Official Transcript of Proceedings
NUCLEAR REGULATORY COMMISSION

Title: Advisory Committee on Reactor Safeguards
Subcommittee on the Westinghouse AP1000
DCD and Vogtle Units 3 and 4 COL

Date: Thursday, June 24, 2010

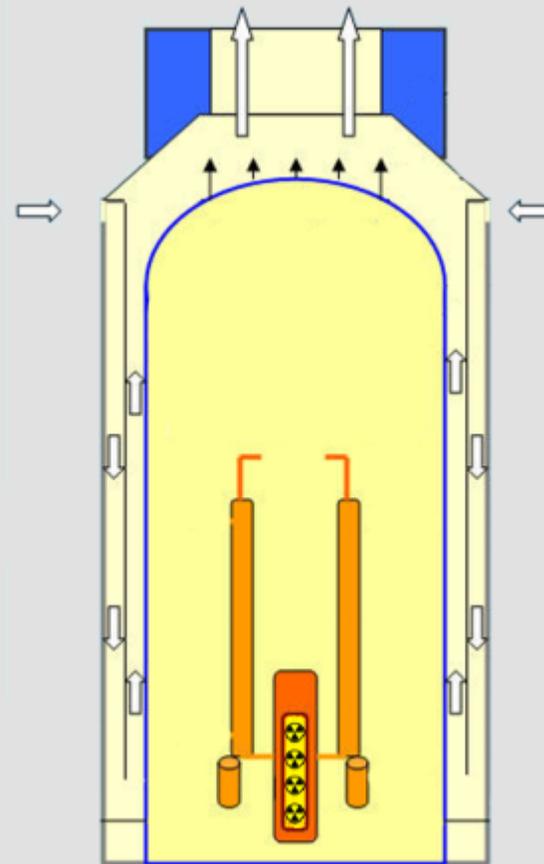
Wall-brackets on the outside of the AP1000 containment create crevices that allow for moisture build-up and creates a corrosive environment.

The junction between the wall and the floor creates a crevice that allows for moisture build-up and creates a corrosive environment.

AP1000
Chimney Effect
Draws
Radioactivity
Directly Into The
Environment

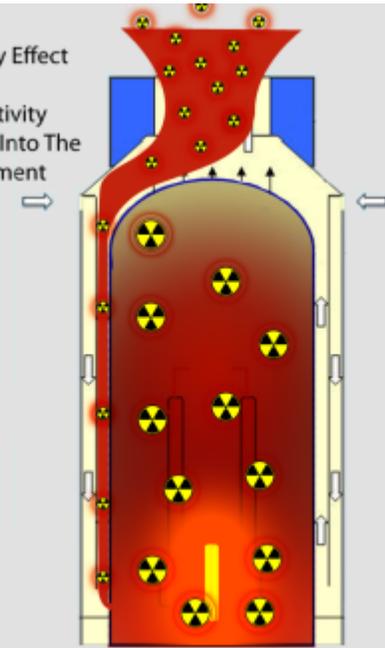
For its SAMDA analysis, Westinghouse assumes a late containment failure (CLF), a failure of the containment to isolate (CI), and bypass through an open piping system (BP).

For the CLF, CI, and BP scenarios, Westinghouse assumes that containment leakage is into other filtered areas of the plant and is not released directly into the environment.

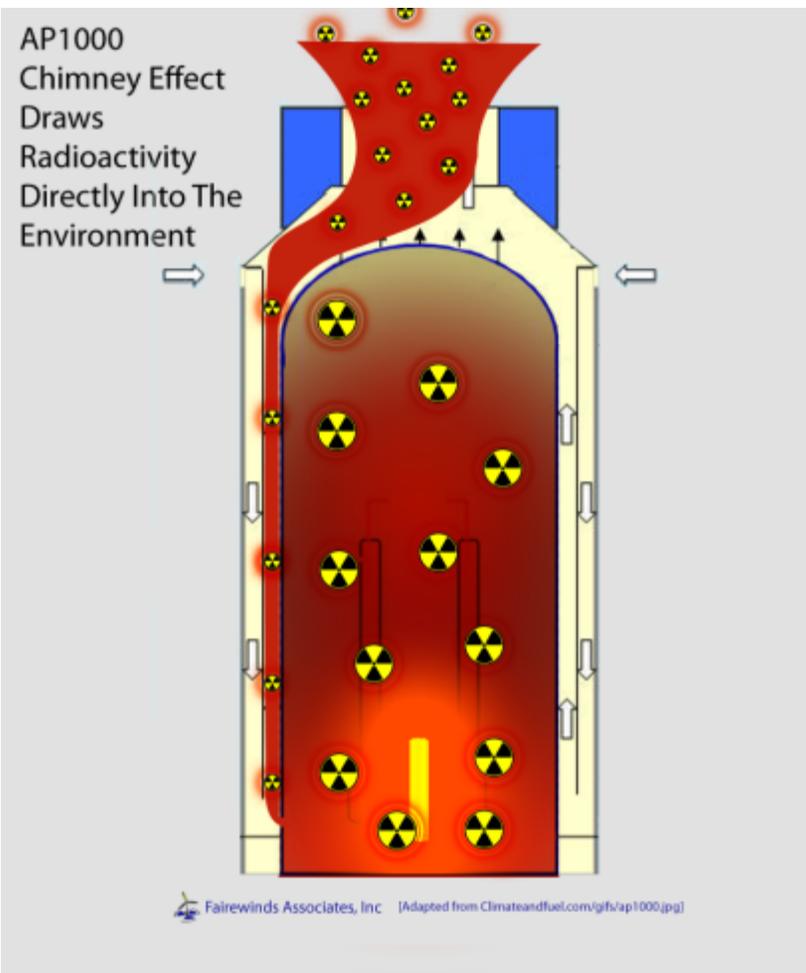
Both Westinghouse and the NRC assume that ASME XI inspections and protective coatings applied to the outside of the AP1000 containment will reduce the risk of a pinhole leak to **ZERO**.

Fairewinds analysis of 40-years of problems associated with the integrity of containment shows there is a relatively high probability of a pinhole leak in the AP1000 containment.

Should this pinhole leak exist, post accident pressures of 50-psi inside the containment will push radioactive gases into the annular gap causing off-site doses to exceed 10 CFR 100 allowable exposure levels.

AP1000
Chimney Effect
Draws
Radioactivity
Directly Into The
Environment

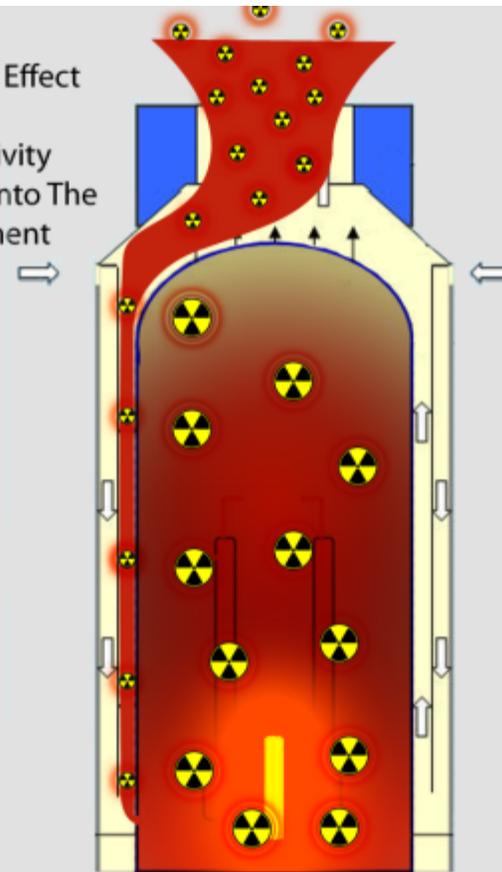
Even this proposed option does not completely eliminate Fairewinds’ concerns as leakage into the annular gap through a pinhole leak in the containment wall might not be captured.
